Subject: Cabot Reading Site, Reading, Pennsylvania (License No. SMC-1562)
Radiological Assessment and Decommissioning Plan
Rip-Rap Cover Design Modifications

As discussed in our telephone conversation on June 8, 2005, Cabot Corporation proposes to modify the design of the rip-rap cover described in reference 1. The changes resulted from a meeting with parties involved in redevelopment of the former American Chain and Cable (ACC) property and the former Dana Oley Yard (Dana) north of the subject site. The meeting reviewed the proposed rip-rap cover in the context of the current redevelopment plans.

CABOT
Reading, Pennsylvania Slag Pile Site
Revision 3 Replacement Pages Instructions

**Revision 3
June 2005**

FIGURE 1-12
PROPOSED RIP-RAP
COVER LOCATION

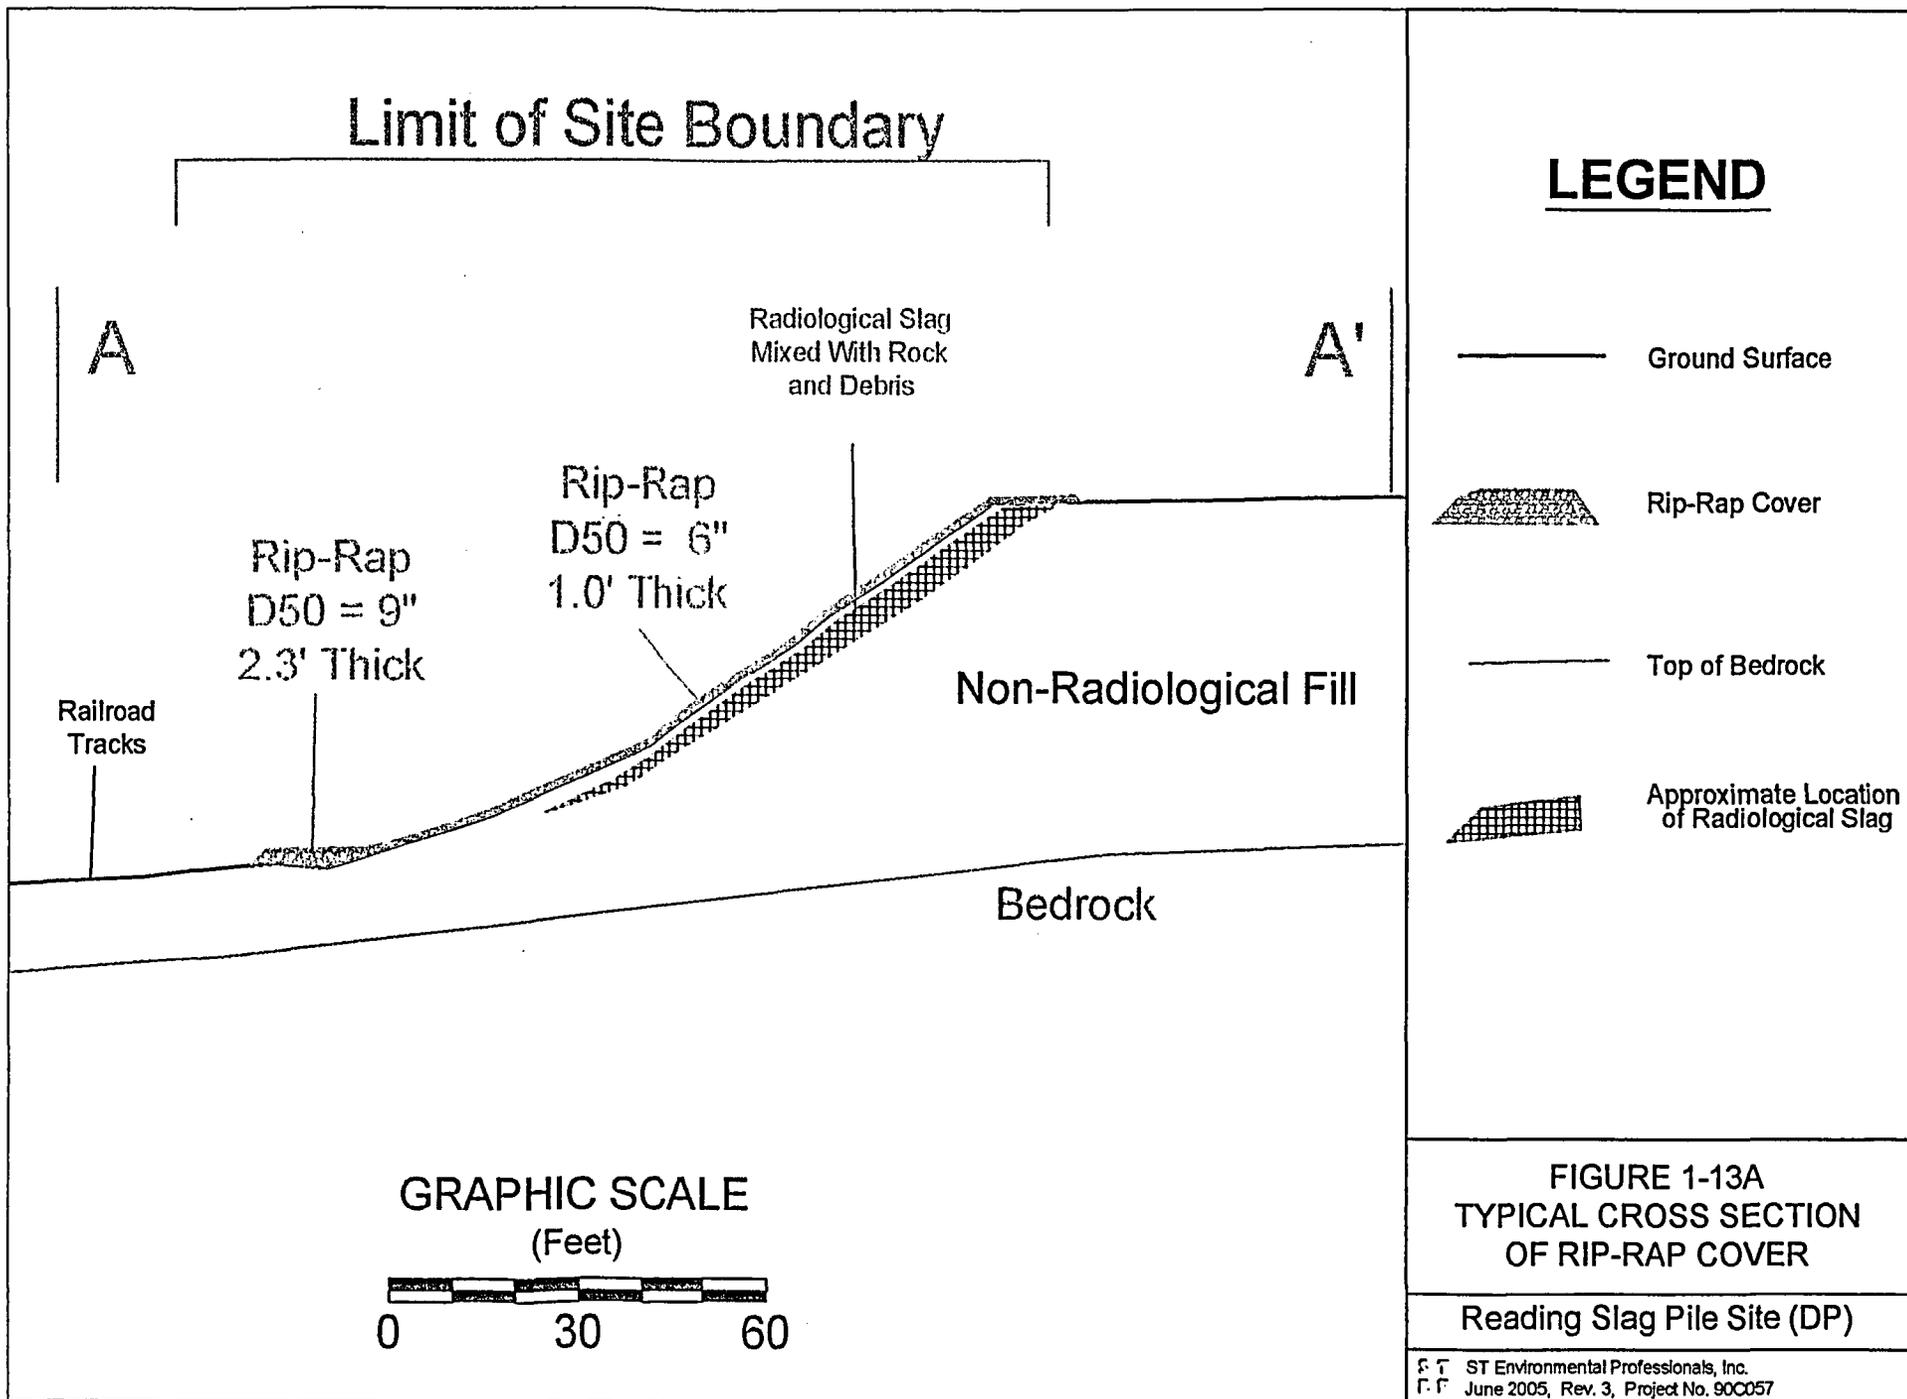
The participants in the meeting concluded that the planned extension of River Road to provide improved access to the Dana property would benefit from a thinner and smaller area of rip-rap in the River Road right-of-way (ROW). To evaluate the feasibility of changing the rip-rap design, Cabot inspected the ACC property. The inspection found that the upper portion of the ACC property drains to the south and east, away from the top of the slope containing the slag. The rip-rap design calculations provided in reference 1 conservatively assumed that the area within 500 feet of the slope drained on to the slag pile. Revised calculations, using the actual topography, resulted in a reduction of the required rip-rap rock size, thickness and width of the rip-rap base extending into the ROW. In addition, the calculations indicated that the rip-rap only needs to extend to the top of the topographic bench in the southern portion of the slope. The revised design, consistent with the calculations, remains compliant with NUREG-1623.

The rip-rap cover design was performed by an experienced geotechnical engineering firm using the guidelines in NUREG-1623. The detailed calculations and procedures for installation are contained in Appendix E. On the slope and top edge of the pile, the cover will consist of a 1.0 foot thick layer of durable rock with an average size of approximately 6" ($D_{50}=6''$). At the base of the slope, a 2.3-foot thick layer of $D_{50}=9''$ durable rock will extend 11 feet from the slope to form a base to anchor the slope. The rip-rap cover is depicted in plan view on Figure 1-12 and cross section in Figures 1-13A and 1-13B.

FIGURE 3-2
TYPICAL CROSS SECTION
OF RIP-RAP COVER

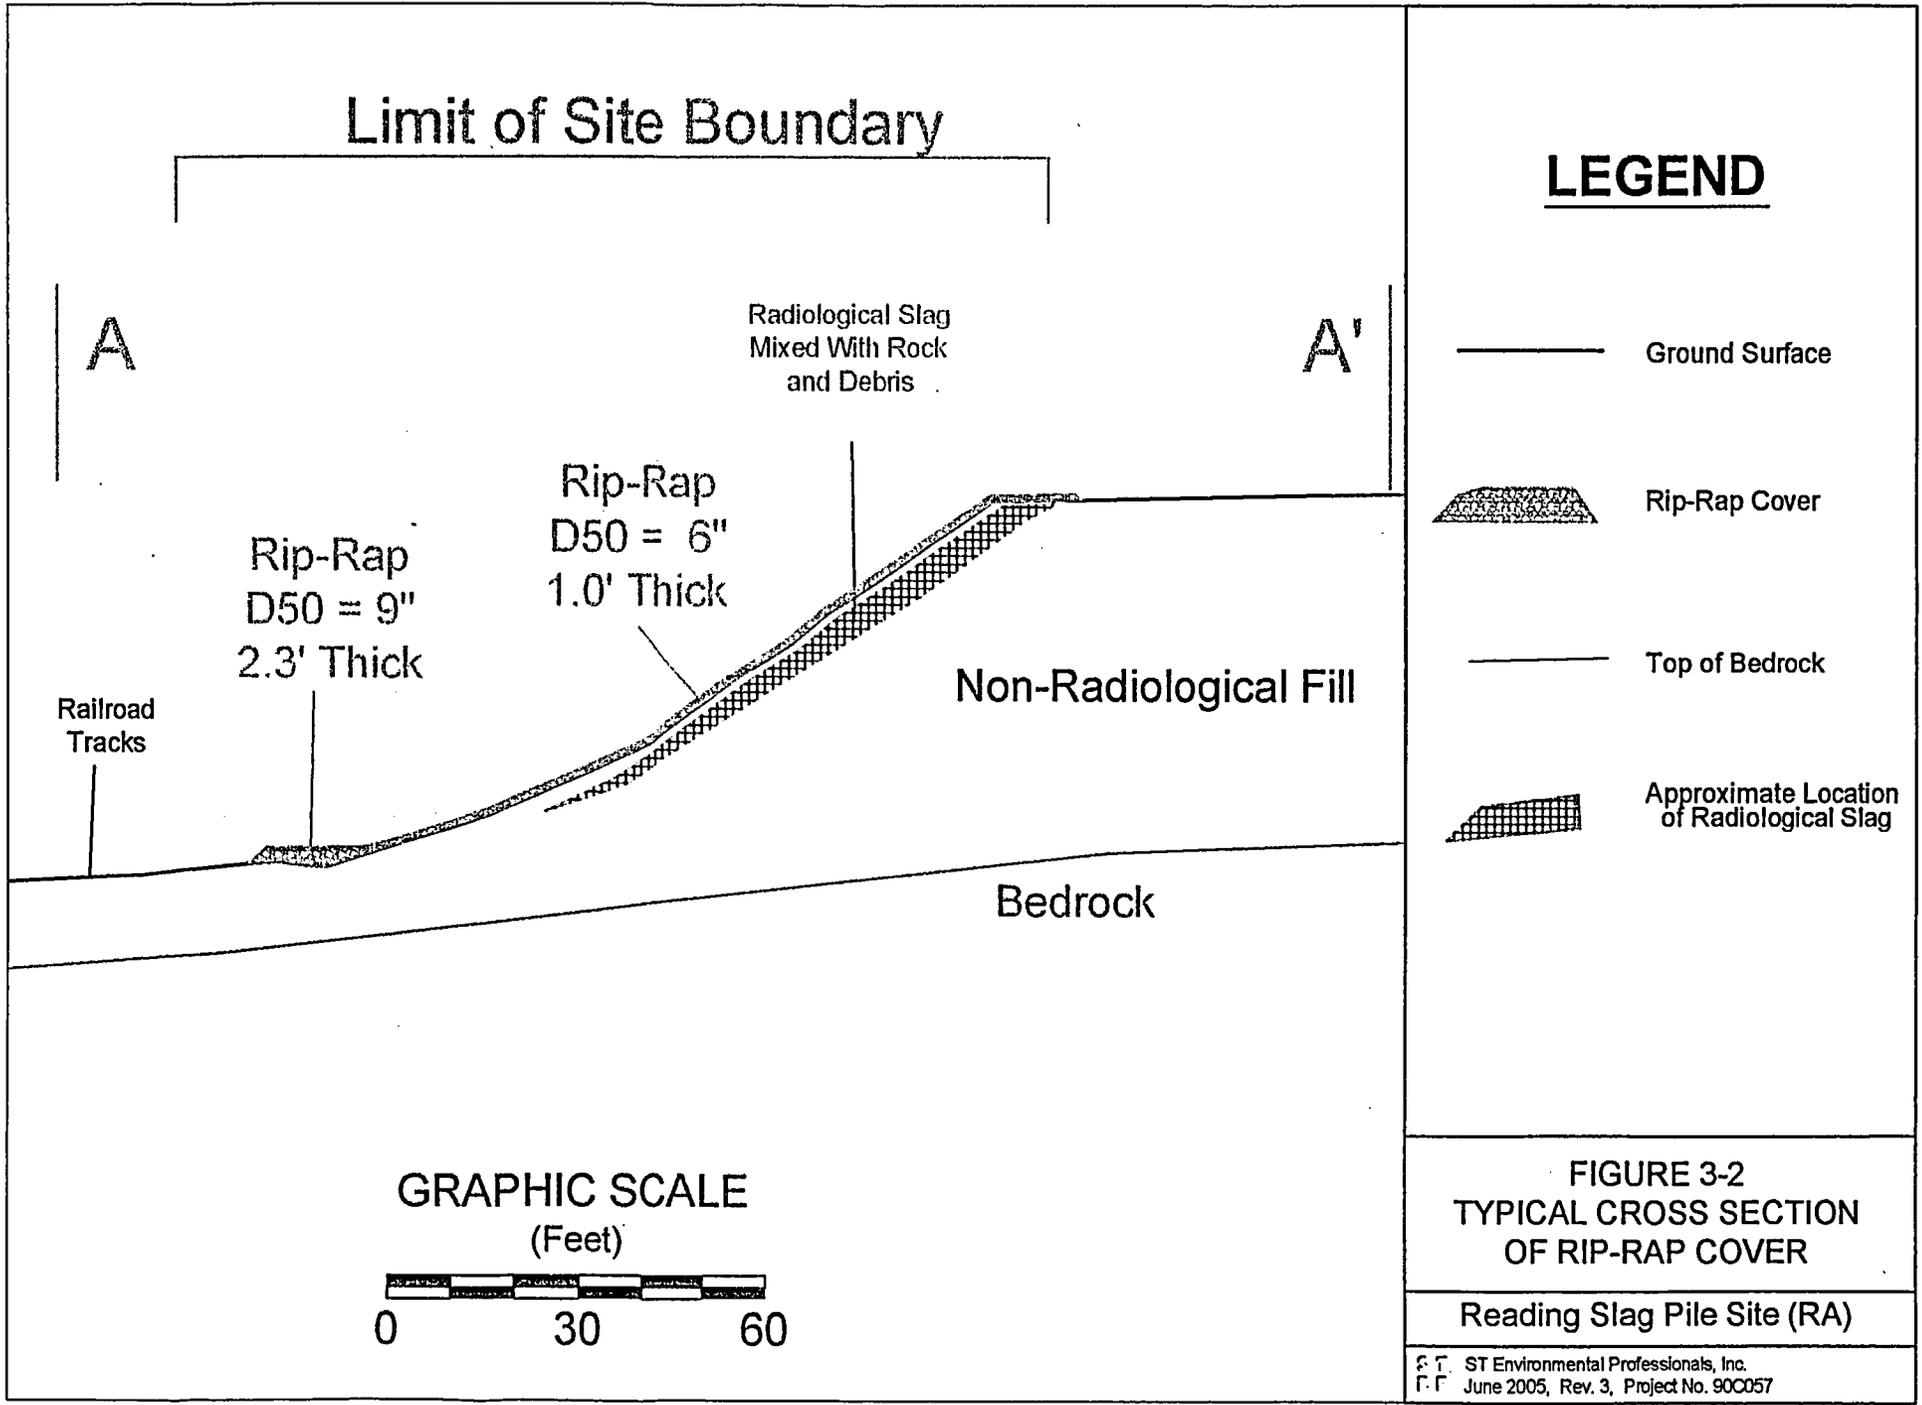
The Decommissioning Plan incorporates emplacement of 1.0-foot thick layer of rip-rap, on the slag pile slope face and along the top edge. A 2.3-foot thick rip-rap apron will extend 11 feet from the bottom of the slope into the River Road ROW to anchor the slope. The rip-rap is intended primarily for added assurance that erosion will not occur over the period of interest. Given this limited purpose and the self-armoring properties of such measures, this feature constitutes a passive engineered barrier, as described in NRC guidance (USNRC, 2003b, Section 3.5). The rip-rap cover is designed to remain effective for erosion control for 1,000 years without maintenance. Consequently, no institutional controls will be required after license termination.

The rip-rap cover on the slope and top edge will consist of a 1.0 foot thick layer of durable rock sized $D_{50}=6''$ (USA number R-4 rip-rap). This exceeds the size criteria calculated using NUREG-1623 methods of $D_{50} = 1.3$ for the slope. An apron of rip-rap will be placed extending 11 feet out from the toe of the slope to anchor the rip-rap cover. This will eliminate the need to excavate slag at the toe of the slope. The apron will consist of USA number R-5 rip-rap ($D_{50} = 9''$). This exceeds the design calculation of $D_{50} = 7.2''$. The apron will be 2.3-foot thick to facilitate proper placement of the large size rip-rap. Additional design details are provided in the Decommissioning Plan (STEP, 2005). Figure 1-3 depicts the location and extent of the proposed rip-rap cover. Figure 3-2 depicts the typical cross section.

Rip-Rap
D50 = 6"
1.0' Thick

Rip-Rap
D50 = 9"
2.3' Thick
